## URGENT FIELD SAFETY NOTICE

**REPLY FORM**  
**QIL FY25-EMEA-15-FY25-038 CCD Color Performance Test Failure**

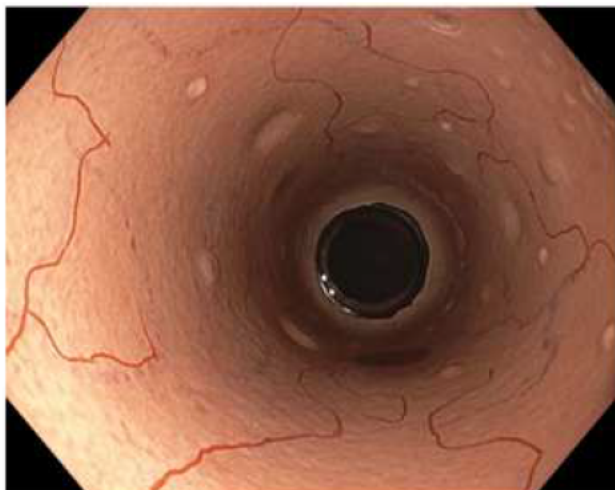
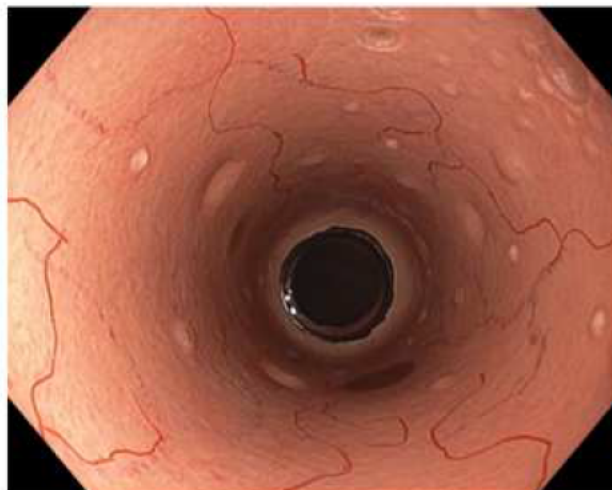
It was discovered during device performance testing that the CCD imaging sensors were programmed with the incorrect color correction data and therefore, specifications are not met. The overall effect on the device is a slightly less intense or faded representation when compared to the desired color, and in addition the color blue is slightly shifted to a more purple shade. See images below.

Incorrect color correction data

Correct color correction data

Incorrect color correction data

Correct color correction data

1. Carefully read the content of this notification.
2. Examine your inventory and identify the above-listed device with the affected serial number.
3. Olympus representative will reach out to you to arrange a mutually convenient time for the return of your device to an Olympus Repair Center to receive a color adjustment.
4. If you have further distributed this product, identify your customers, and forward them this notification.
5. Olympus requests that you acknowledge receipt of this letter. Indicate on the Reply Form that you have received and understood this notification by filling out and returning the completed enclosed Reply Form back to your local Olympus representative **XXX** latest by **XXX**.
